**Regular Meeting of the Historic
Districts Review Board
February 10, 2026, at 5:30 PM
Council Chambers, City Hall
200 Lincoln Avenue**

Meeting Minutes

PROJECT 2025-011246-HDRB. 532 Calle Corvo. Downtown & Eastside Historic District. Contributing.

2025-011246-HDRB. 532 Calle Corvo. Downtown & Eastside Historic District. Contributing. John A. Padilla, agent for Susan McShane Salomone, owner, requests approval to construct a 620 sq. ft. addition to the main house and 518 sq. ft. addition to the garage. Four exceptions are requested to 14-5.2(D)(5)(a)(i) removal of windows and doors of a contributing structure, 14-5.2(D)(2)(d) additions are not permitted to the side of the existing footprint unless the addition is set back a minimum of ten (10) feet from the primary facade, the addition shall not exceed fifty percent of the square footage of the existing footprint and shall not exceed fifty percent of the existing dimension of the primary facade.

Figure 2. Existing and Proposed Floor Plan for the main residential structure.

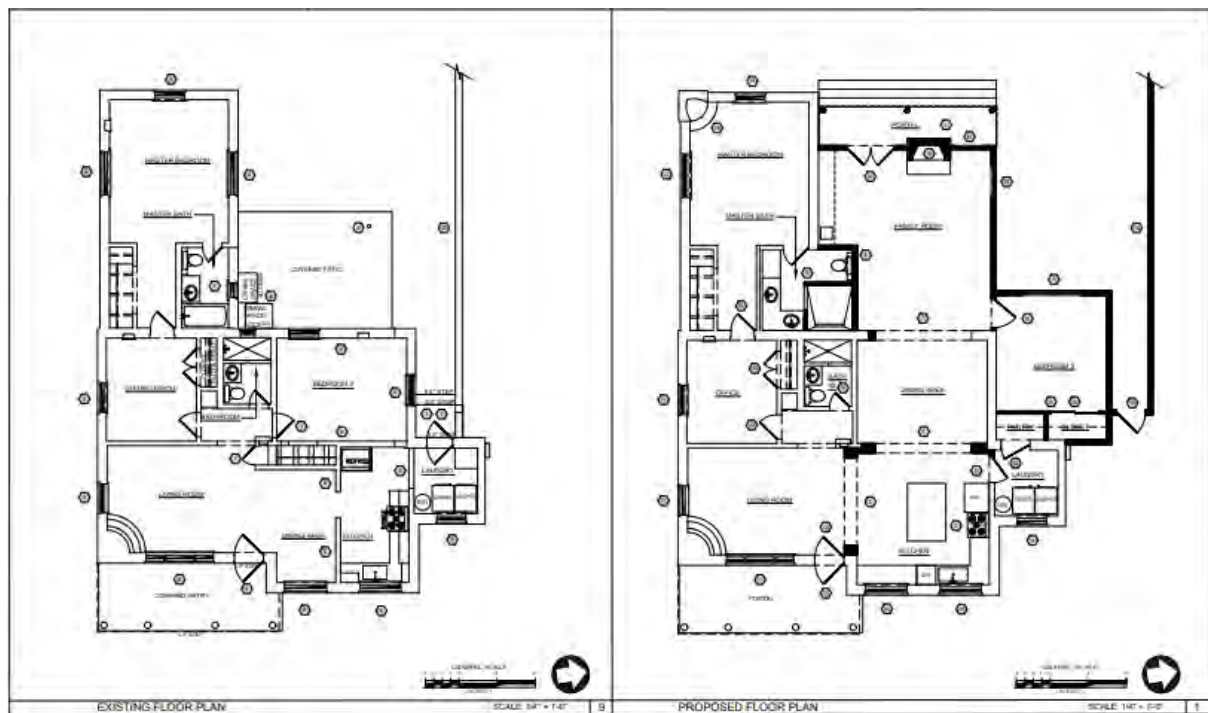
Ms. Lamboy responded that the existing portal and deck are not historic and are not included in the historic footprint. The applicant has indicated an addition of 421 square feet to the historic footprint, which is under 50% of the existing 1619 square feet.

Member Cherry noted that, in any case, the addition to the main structure is under 50%.

Figure 3. Existing and Proposed Floor Plan of the garage structure.

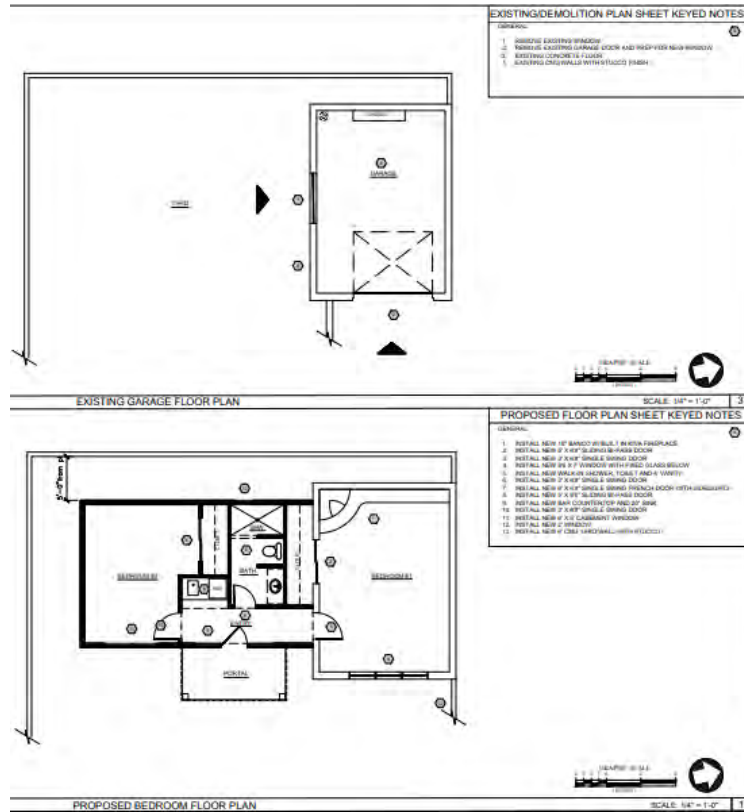
- 6) Renovation of the existing garage into a new bedroom within the historic footprint of 362 sq. ft. of the garage, exception requested to 14-5.2(D)(2)(d) additions are not permitted to the side of the existing footprint unless the addition is set back a minimum of ten (10) feet from the primary facade.

- 7) Addition to the existing garage of a portal, entry area, closets, and a bathroom for a total proposed area of 518 sq. ft., exceeding 50% of the historic footprint of the garage by 337 sq. Ft, exception requested to 14-5.2(D)(2)(d) the addition shall not exceed fifty percent of the square footage of the existing footprint.

Staff Response: Staff has evaluated the applicant's response and finds that the criterion has not been met. The proposed design completely changes the current contributing condition of the Garage and will threaten the status.

Staff Response: Staff has evaluated the applicant's response and finds that the criterion has not been met. The proposed changes to the contributing garage structure will completely change the use and design in which the Board made a previous motion to preserve. The current request for alterations on the main residential structure do not need an exception request and should be adequate to meet the needs of the homeowners.

Staff Response: Staff has evaluated the applicant's response and finds that this criterion has not been met. The proposed 518 sq. ft. addition envelopes the current 337 sq. ft. Garage and completely changes the current contributing condition of the garage which will threaten the status.

Staff Response: Staff has evaluated the applicant's response and finds that the criterion has not been met. The proposed 518 sq. ft. addition changes the current 337 sq. ft. contributing Garage structure and changes the use and design in which the Board made a previous motion to preserve. It is the expectation that building character be maintained; the large addition completely changes the character of the structure. Incremental changes such as this can establish a precedent and cause a much greater degree of change across all historic districts.

Figure 4. Existing and Proposed East Elevation and Primary Facade of the main residential structure.

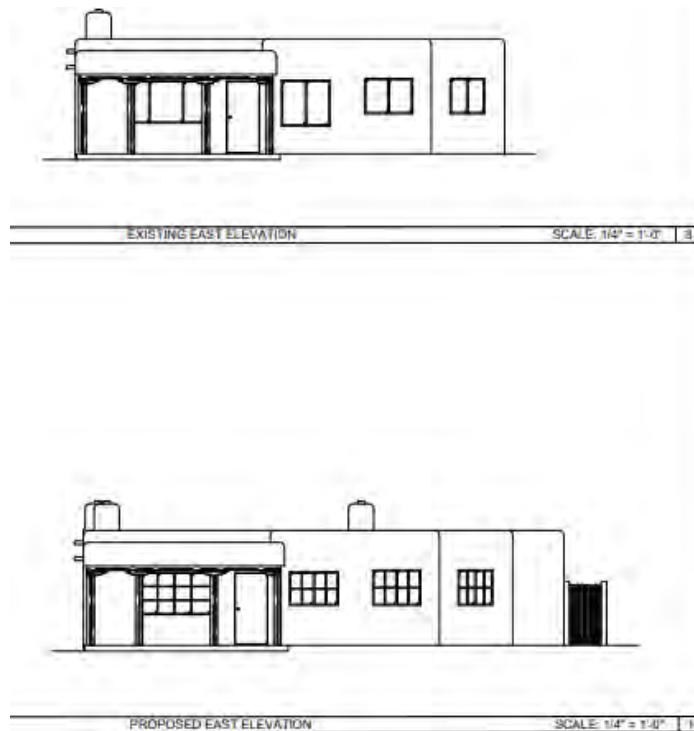
Exception to 14-5.2(D)(5)(a)(i) to narrow a historic window opening on the primary facade of a contributing structure from 4’-07” wide by 4’-04” high to 4’-07” wide by 3’-02” high:

Staff Response: Staff has evaluated the applicant’s response and finds that the criterion has been met. The proposed narrowing of the historic window opening from 4’-07” wide by 4’-04” high to 4’-07” wide by 3’-02” high, will not adversely impact the historic contributing status or primary façade of the structure. The proposed divided lite window is in compliance with the historic district standards.

Staff Response: Staff has evaluated the applicant's response and finds that the criterion has been met. The proposed narrowing of the historic window opening will provide the owner with the upgraded energy efficiency requested while maintaining the historic district standards.

Figure 5. Existing and Proposed East Elevation and Primary Facade of the garage structure.

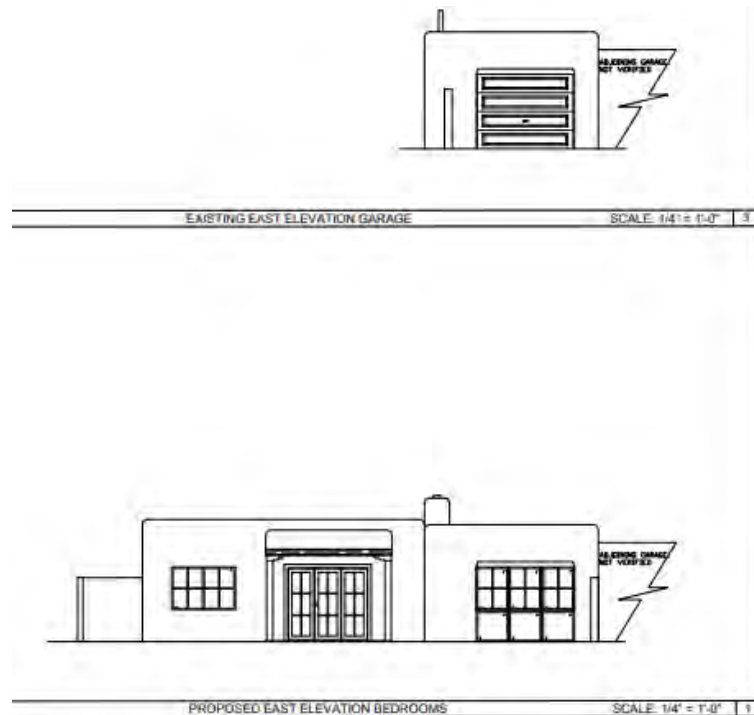
Ms. Lamboy responded that the Board has permitted additions to historic garages, but not of the proposed size. Replacing the garage door with a window could be problematic.

- 8) Removal of the non-historic tilting garage door from the east façade, but preserving the existing opening, allowing the opening to read as a historic opening, exception requested to 14-5.2(D)(2)(d) shall not exceed fifty percent of the existing dimension of the primary facade.

dimension by 10'-6" along the east façade which changes the overall character of the Garage which the Board has determined is worth preserving.

Staff Response: Staff has evaluated the applicant's response and finds that the criterion has not been met. The proposed impact on the primary façade should be reconsidered and not diminish the character defining presence on the streetscape.

Staff Response: Staff has evaluated the applicant's response and finds that the criterion has not been met. The proposed addition and impact on the primary façade should strengthen the contributing garage not completely change the look and use of what the Board has determined is worth preserving.
